**From:** Blacker, Katherine <blackerk@grotonutilities.com>  
**Sent:** Monday, April 27, 2026 12:56 PM  
**To:** Hannah Gienau; Elizabeth Burdick; Anna Wynn  
**Cc:** LaFontaine, Doug; Acimovic, Karl; Monk, Cassidy; Pratt, Joseph; water pollution control authority  
**Subject:** Comments - 1947 Center Groton Road Residential Development - WIP#2-1864  
**Attachments:** 1947 Center Groton Rd\_WIP02-1864\_GU Water & Watershed Comments\_04-24-26.pdf; GU WATER SPECS\_SELECTION.pdf; L0098\_Water Main Record Plan.pdf

CITY OF GROTON  
DEPARTMENT OF UTILITIES  
SITE PLAN REVIEW SHEET

Title of Plan Multifamily Residential Dvlpt. - 1947 Center Groton Rd Latest Revision Date 04/22/2026

Location 1947 Center Groton Road, Ledyard Center W.I.P. # 02-1864

Gate valve on both sides of hydrant - for isolation

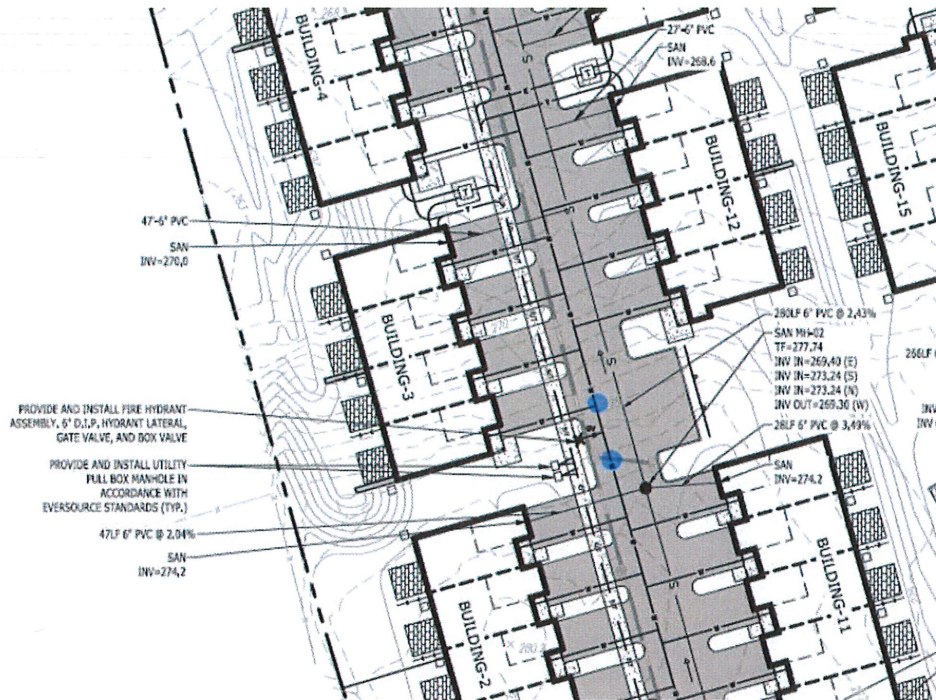
- c. Note 6’ min. horizontal separation from UG telecommunications and electric.
  - d. Recommended showing additional gate valves at driveway entrance for isolation, and three-way valves at all hydrants.

- e. See images below:
